AMENDMENT ON REDUCTION GEARBOX TYPE „C“ AND TYPE “E” FOR ROTAX® 2-STROKE UL AIRCRAFT ENGINES SI-06-1998

view: installation sleeve assy / C-gearbox
Fig. 1, 2 and 3

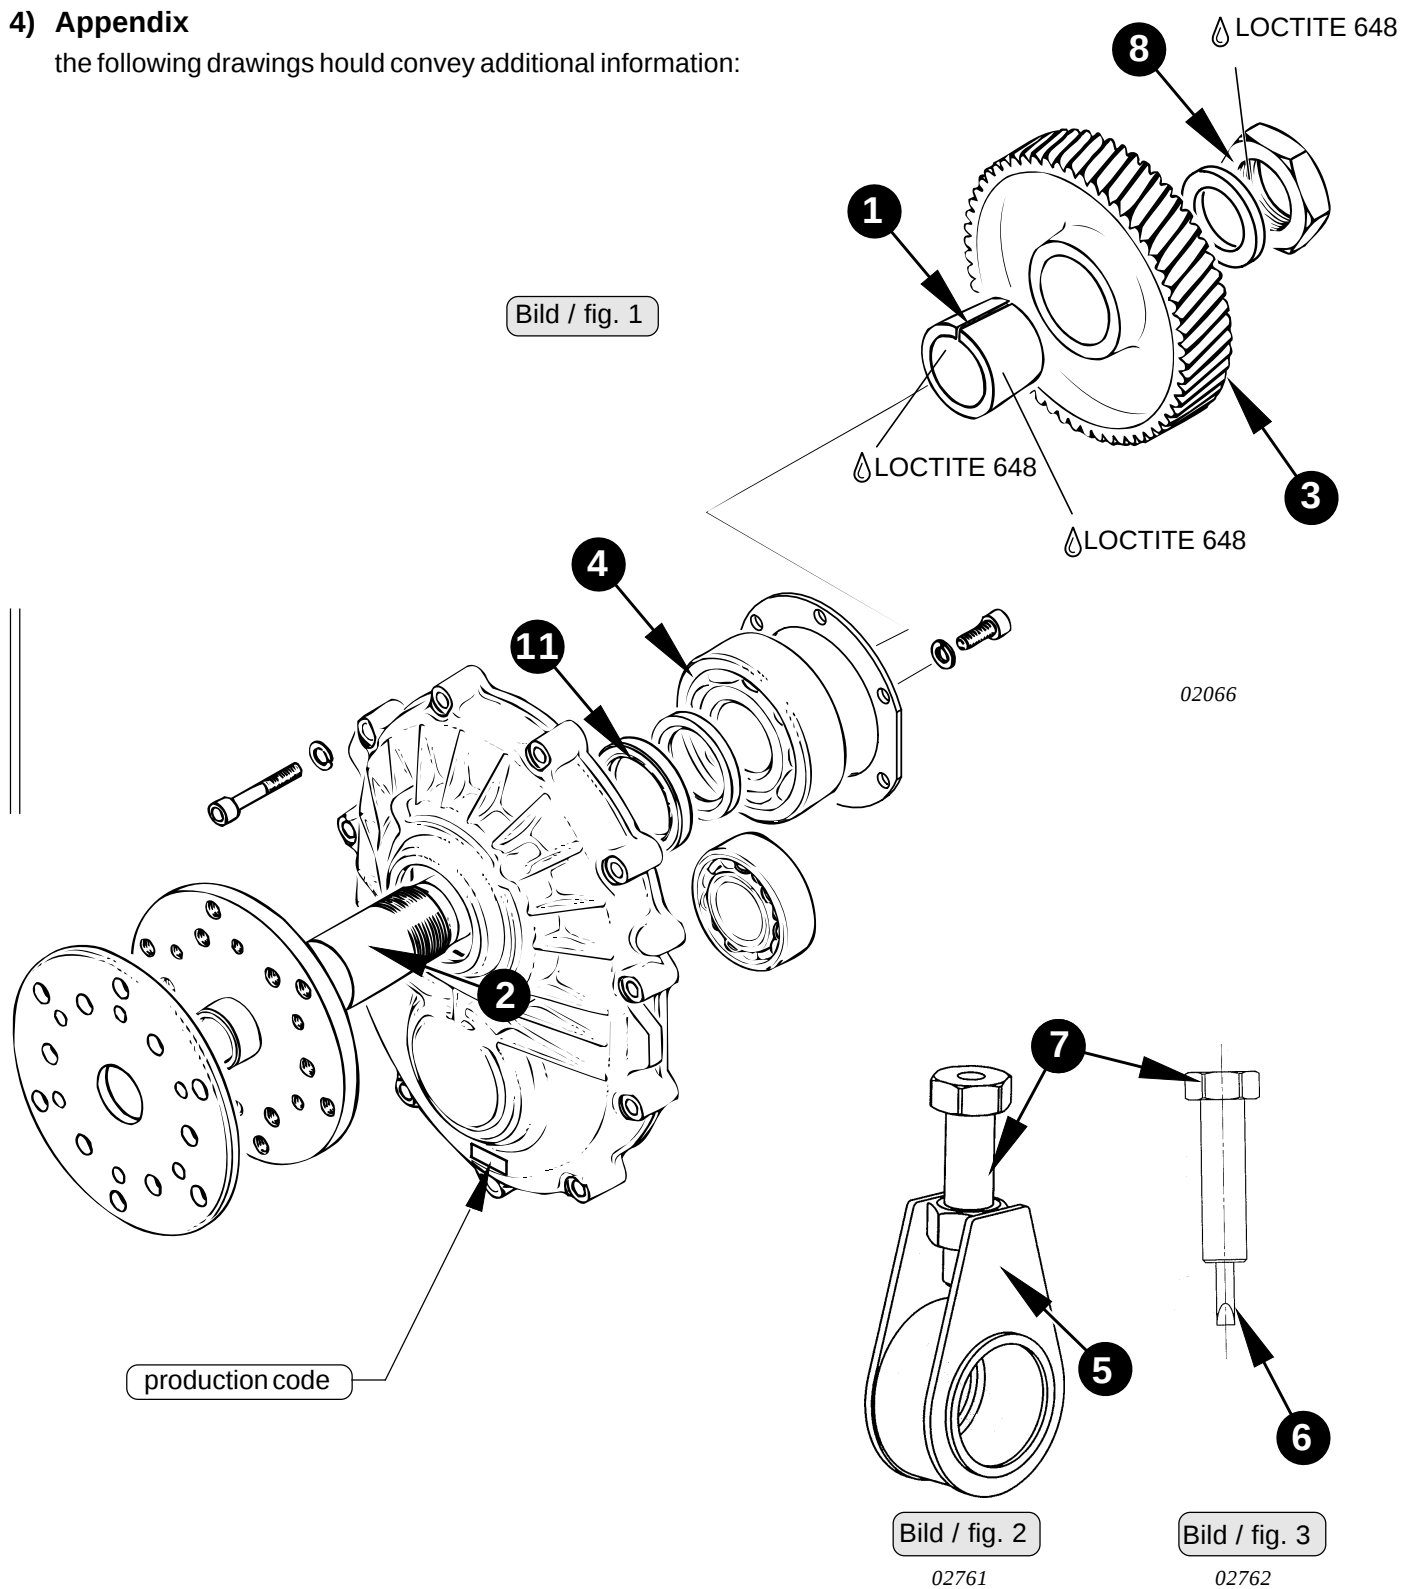
- Disassemble the reduction gearbox in accordance with the current Repair Manual for engine type 462-532-582 to a state where the cone sleeve (1) can be removed.
- Clean and degrease cone sleeve (1).
- Degrease propeller shaft (2) and lay shaft gear (3).

- ◆ NOTE: Use of a different tool (screw driver etc.) is inadequate and could result in damage of cone sleeve and propeller shaft. Use exclusively installation sleeve assy (5) (part no. 877 810).

- Place cone sleeve (1) into installation sleeve assy (5). Make sure that the rotating shaft (6) of the pressure screw (7) comes to rest in the slot of the cone sleeve (1).

- Using a spanner move shaft (6) into slot until the cone sleeve (1) expands enough.
- CAUTION: But ensure that the shaft will not move beyond inside dia. of the sleeve. Otherwise you risk damage to the propeller shaft.

- Apply LOCTITE 648 on inside of cone sleeve (1).
- ▲ WARNING: Make absolutely sure that no LOCTITE will enter into the ball bearing (4).
- After placing cone sleeve (1) into position on propeller shaft slacken the pressure screw (7) and remove the tool.

- Apply LOCTITE 648 on outside of cone sleeve (1).
- The tightening torque of the hex. nut (8) has been newly specified to **250 ±10 Nm (185 ±7 ft.lb)**.

view: puller assy
Fig. 4 and 5

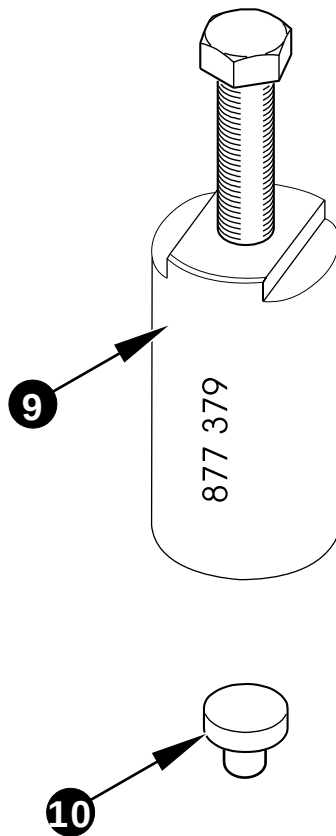
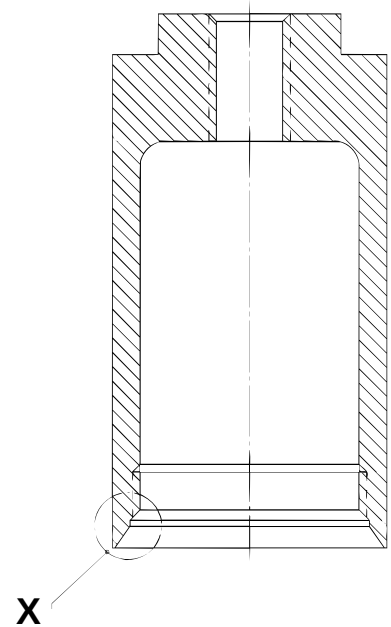
Because of the changed assembly procedure the puller (9) for the layshaft gear has been modified. The new tool is fashioned with a chamfering at the base of the puller (9), thus achieving the best stability at pulling-off procedure. Furthermore the other end of the puller is now flat sided 36 A/F to tighten the puller (9) into position.

- Place the mushroom-shaped protection piece (10) part no. 877 415 into the centering of the propeller shaft (2).
- Preheat the layshaft gear (3) (gluing area) with a hot air gun to approximately 300°C (570°F) to reverse the glue effect.

- CAUTION: Hot components risk of injury.
- Fit the puller assy. (9) part no. 877 379 on layshaft gear and tighten with open and wrench 36 A/F.
- Screw-in and tighten the puller screw. Remove propeller shaft assy complete with gear cover and puller assy from the fixture. If necessary separate the layshaft gear by a blow of the hammer on the tightened puller screw.
